COMMENT ON RESPONSE SUBMITTED FOR DEADLINE 5 from Tom Lloyd

This submission is a comment on the following documents, and relates to the location of Fenrother junction on Part A :-

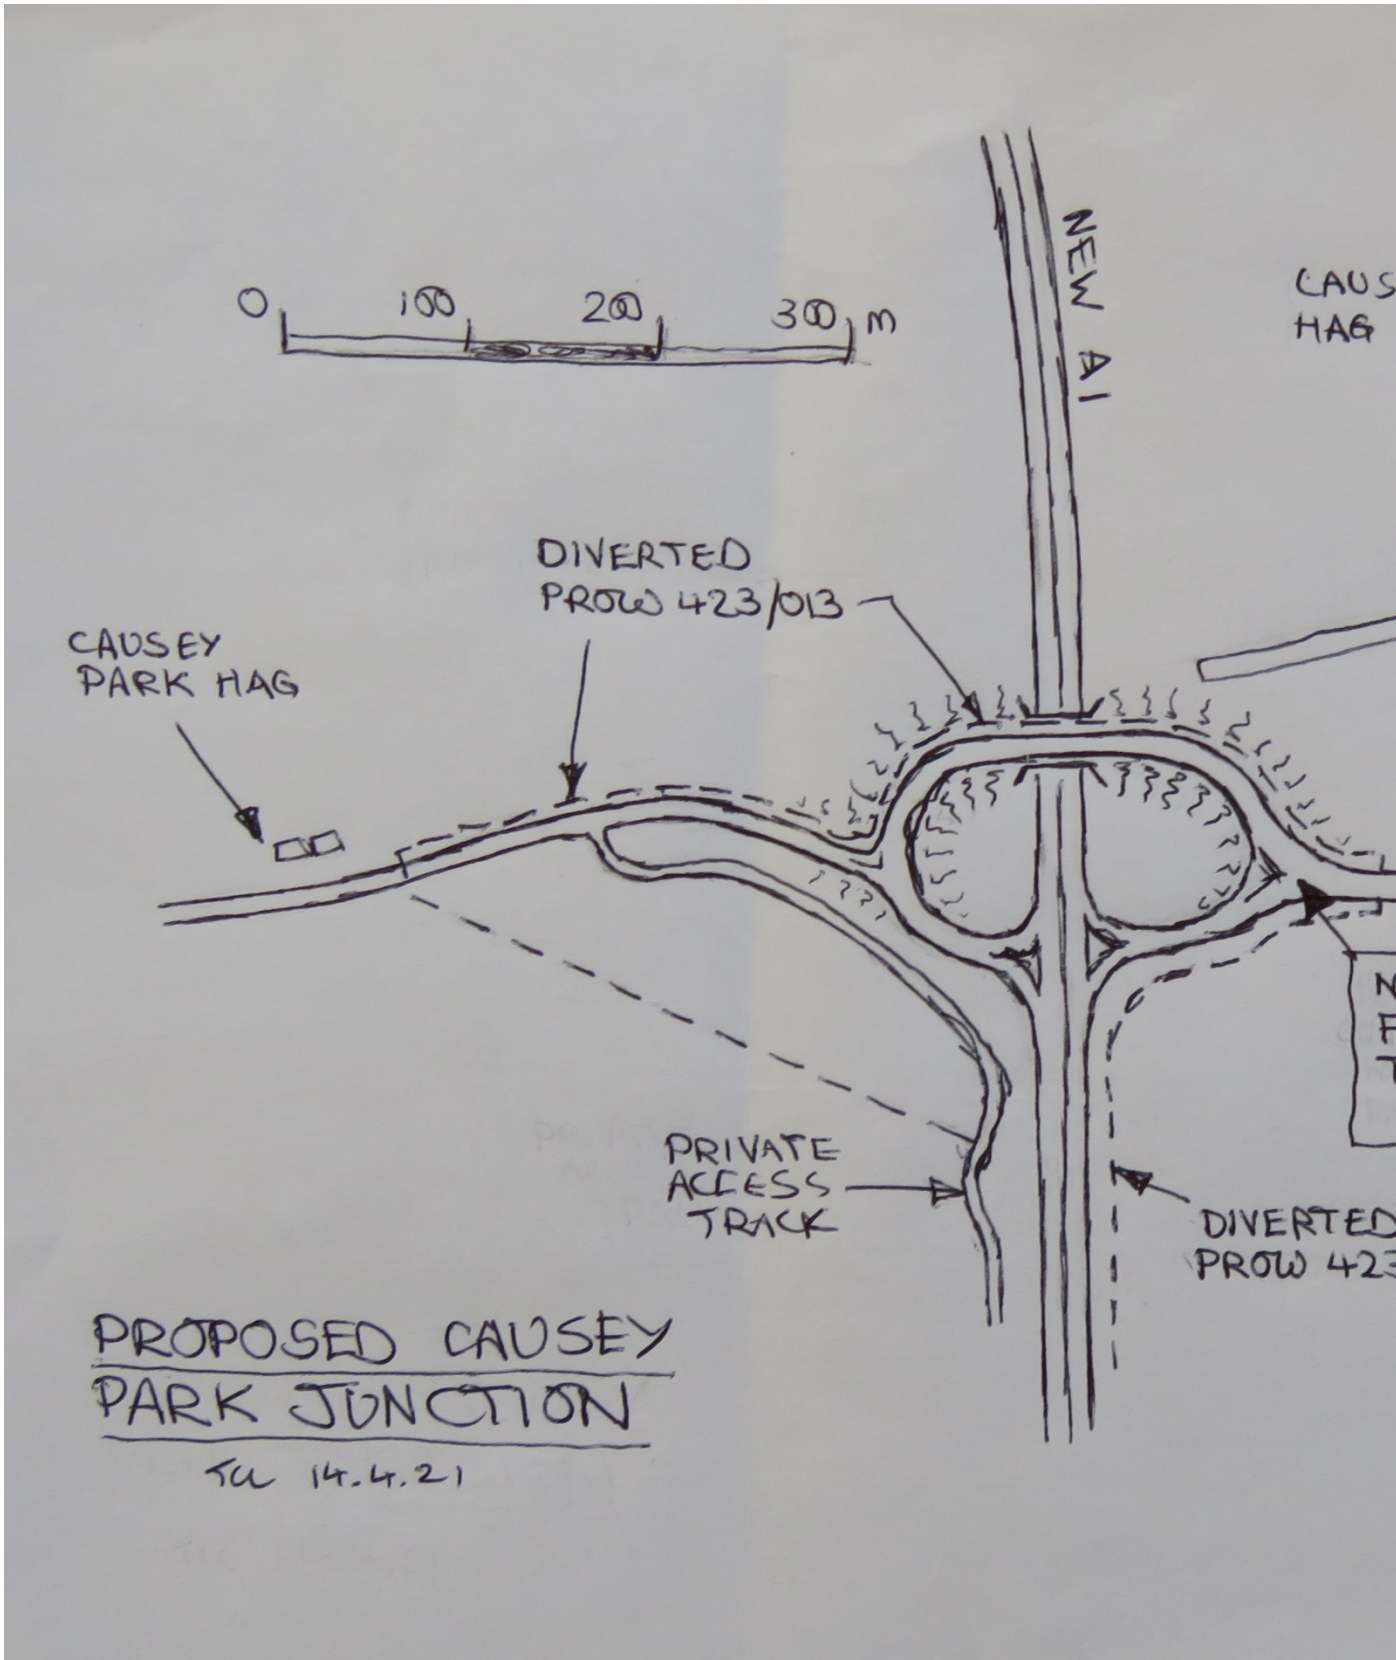
Having commuted daily from Amble to Newcastle for 9 years, I have been questioning why Fenrother junction is not located 2.7km further north at the much busier Causey Park junction ever since the preferred offline route for Part A was announced in 2017.

Although Document 2 above tried to justify the junction location at Fenrother, it still leaves unanswered questions that are reinforced by NCC's concerns in Document 2 regarding non-motorised users of the detrunked A1. The current proposal means c.2,500 vehicles/day accessing the new A1 south from Chevington Road will face three new frustrations :-

- giving way to a road with less than a third of its traffic at Causey Park (which most of this traffic already does TWICE at West Chevington junctions despite NCC's major upgrades to Chevington Road)
- driving along a newly narrowed detrunked A1 within inches of the non-motorised N-S users for 2.4km to Fenrother
- crossing itself unnecessarily at the east T junction within the Fenrother junction layout, significantly increasing collision risks

I also believe the Fenrother junction should be inverted N-S **WHETHER IT IS SITUATED AT FENROTHER OR CAUSEY PARK**, as the current layout causes all the coastal/A1 south traffic to needlessly cross itself at the east side T junction, thus increasing the risk of collisions

I therefore ask the Planning Inspectorate to reconsider HE’s proposal and the need for HE to show their design is the optimum one and not just an adequate one, which I still do not believe they have demonstrated, **ON ROAD SAFETY ASPECTS ALONE**.

I attach a sketch plan of my alternative junction layout at Causey Park which removes ALL of these frustrations and gives other advantages for a very similar construction cost as far as I can tell from available information.

With my proposal traffic on the detrunked A1 would be dramatically reduced, from c.2,500 to c. 200 vehicles/day, based on NCC's table 36.2, and non-motorised N-S traffic would merely cross coastal access E-W traffic at Causey Bridge, leaving only very local traffic from Burgham Park and Tritlington on the narrowed detrunked A1.
